**Portland General Electric Company**  
*Trojan Nuclear Plant*  
71760 Columbia River Hwy  
Rainier OR 97048  
(503) 556-3713

Trojan Independent Spent Fuel Storage Installation (ISFSI)  
License Change Application (LCA) 72-05 –  
Reduction of the Trojan ISFSI Controlled Area

Trojan Independent Spent Fuel Storage Installation (ISFSI)  
License Change Application (LCA) 72-05 –  
Reduction of the Trojan ISFSI Controlled Area

Figure 1

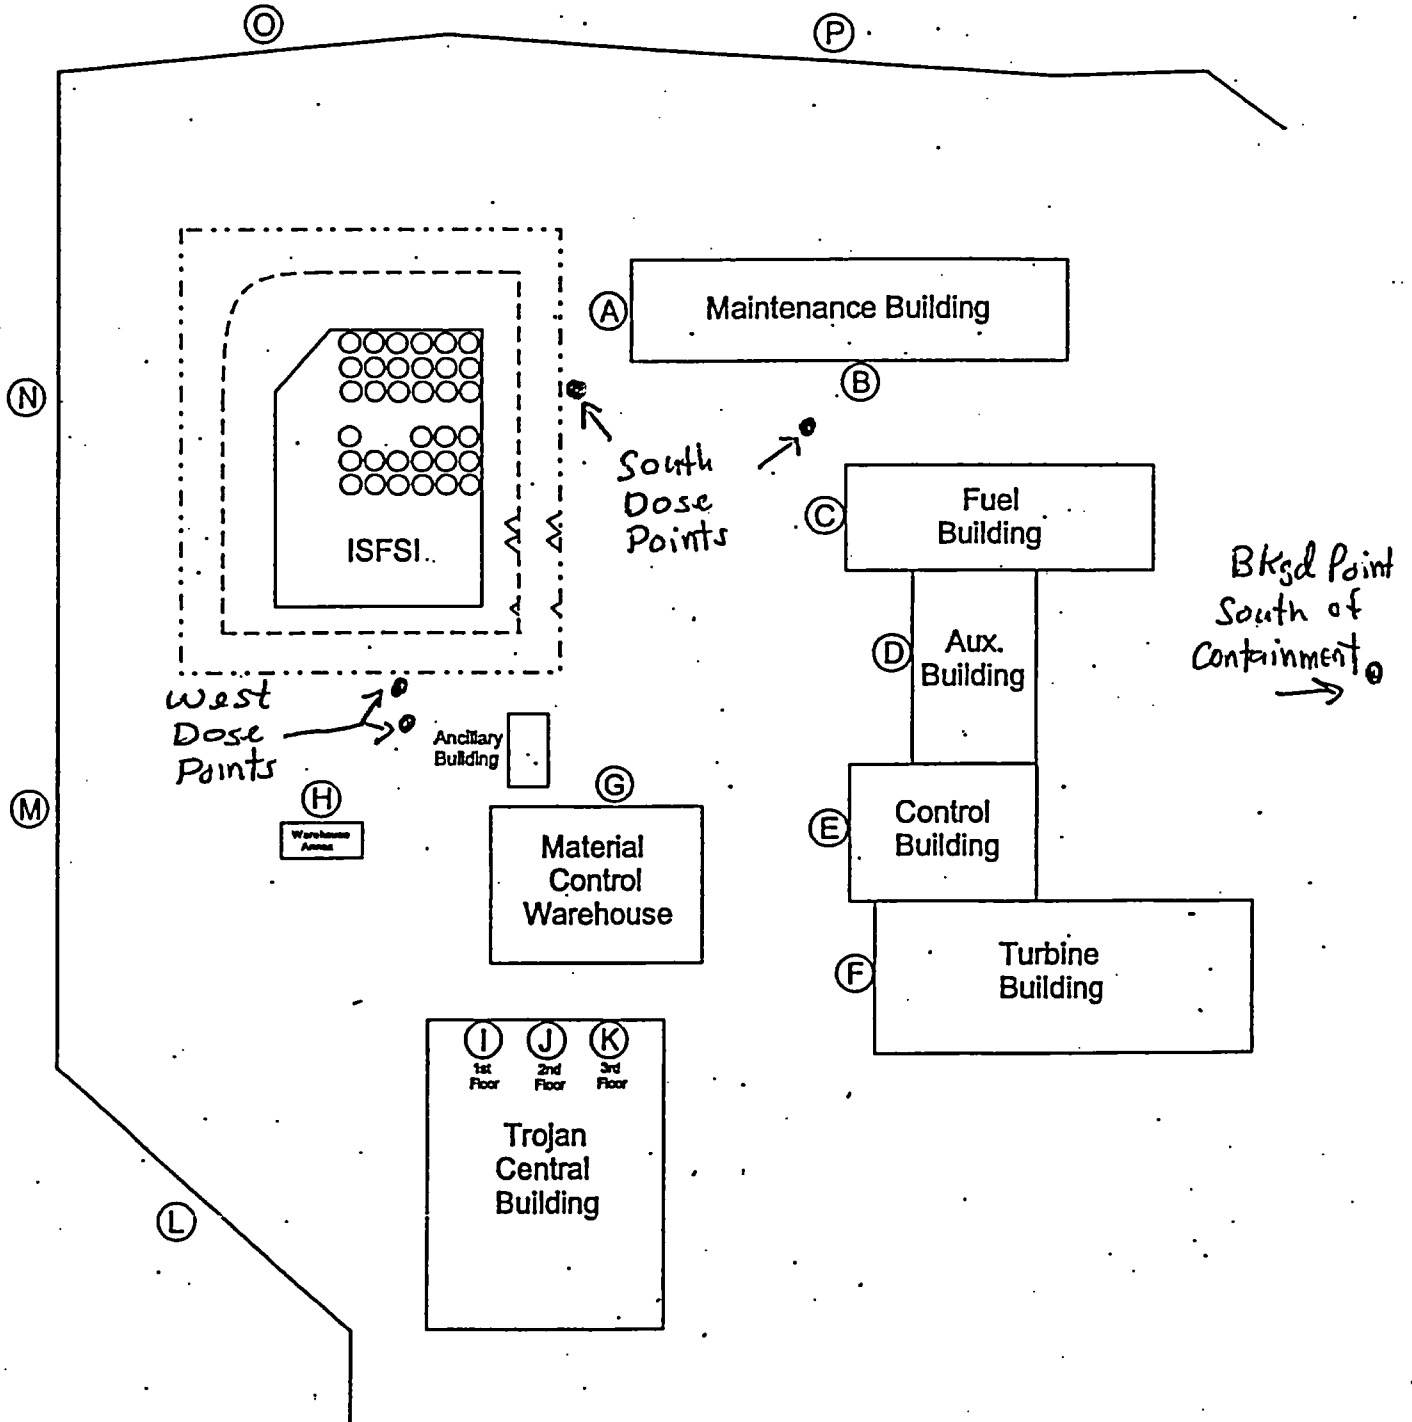
- A. Dose rate measurements were collected on April 21, 2005, using a Bicon Microanalyst serial # B009Q, with a calibration due date of December 16, 2005, at location points marked on Figure 1 of this calculation. These locations were chosen due to direct line of sight with the entire ISFSI array with no significant structures or earthen berms in the way.

FIGURE 2.1-2  
 PGE PROPERTY, ISFSI SITE, AND  
 CONTROLLED AREA BOUNDARY  
 LCA 72-05 Proposed Revision

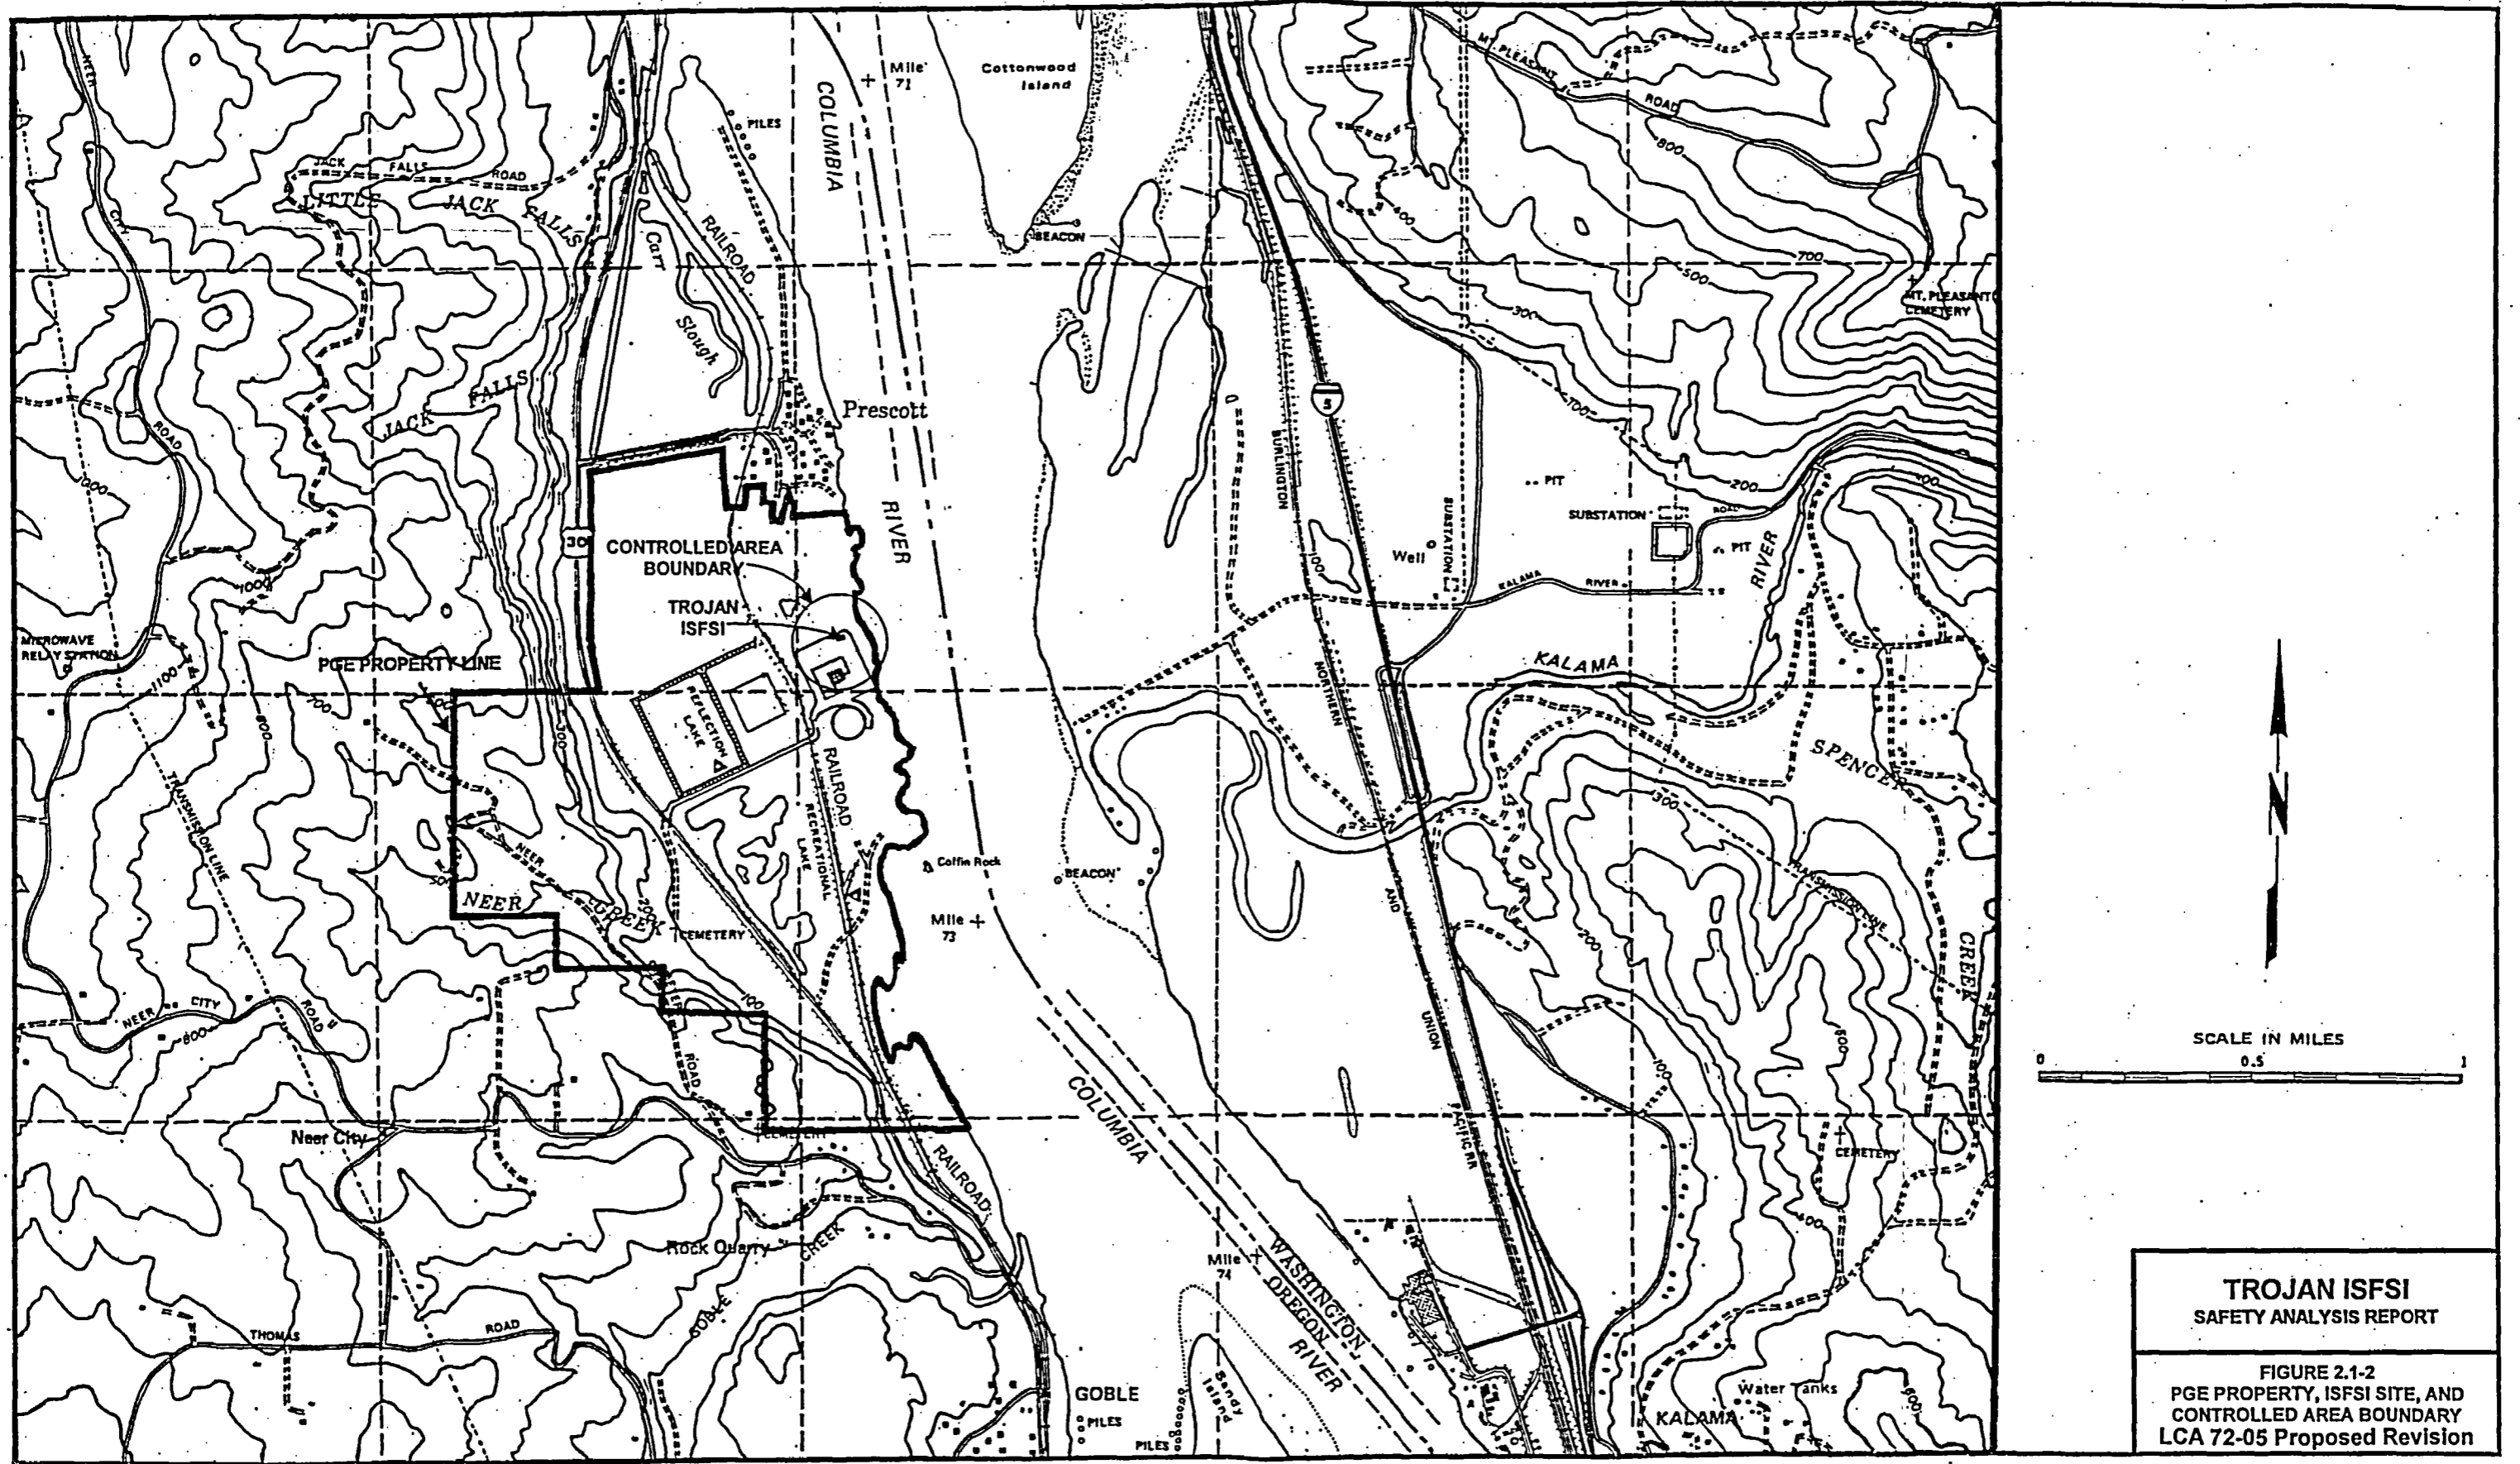
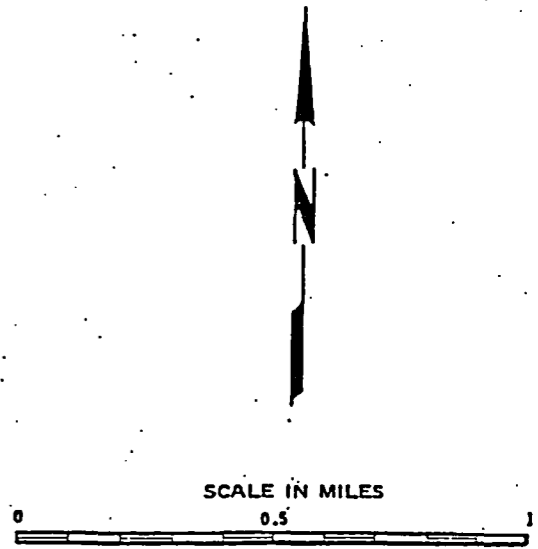
- Figure 2.1-2
    - The depiction of the Trojan ISFSI Controlled Area boundary is redrawn to approximate scale.
  - Section 3.3.5.3
    - In the second paragraph, changes are made to refer to Chapter 7 for additional detail, and to clarify the basis for the dose rate specified as calculated for 100 meters.

- This change graphically reflects the change in the Controlled Area boundary from 300 meters to 200 meters from the edge of the Storage Pad.
  - These changes are made to conform to more extensive changes made in Chapter 7 of the Trojan ISFSI SAR as detailed further below. Specifically, the proposed SAR Chapter 7 revision incorporates the results of two direct radiation dose calculations: one the original shielding analysis results based on ISFSI loading of design basis fuel, and the other the results of Calculation No. TI-159 for establishment of the 200-meter Controlled Area boundary based on actual radiation dose rate measurements. The changes to SAR Section 3.3.5.3 clarify which of these dose calculations support the dose rate specified for 100 meters.

The Controlled Area, as defined in 10 CFR 72.106, immediately surrounds the ISFSI and extends out to 300-200 meters from the edge of the Storage Pad (Figure 2.1-2). The Controlled Area lies entirely on PGE property with the exception of a portion of the Controlled Area that extends over the Columbia River and the Portland & Western Railroad, Inc. right-of-way. U.S. Highway 30 is not within the Controlled Area. PGE has formal agreements with Portland & Western Railroad, Inc. to restrict traffic over their right-of-way, with the U.S. Coast Guard to restrict traffic on the Columbia River, and with the state of Oregon to enable PGE to evacuate persons from publicly owned lands (i.e., tidelands) in the event of an emergency at the ISFSI.

The Controlled Area, as defined in 10 CFR 72.106, immediately surrounds the ISFSI and extends out to 200 meters from the edge of the Storage Pad (Figure 2.1-2). The Controlled Area lies entirely on PGE property with the exception of a portion of the Controlled Area that extends over the Columbia River. U.S. Highway 30 is not within the Controlled Area. PGE has formal agreements with the U.S. Coast Guard to restrict traffic on the Columbia River, and with the state of Oregon to enable PGE to evacuate persons from publicly owned lands (i.e., tidelands) in the event of an emergency at the ISFSI.
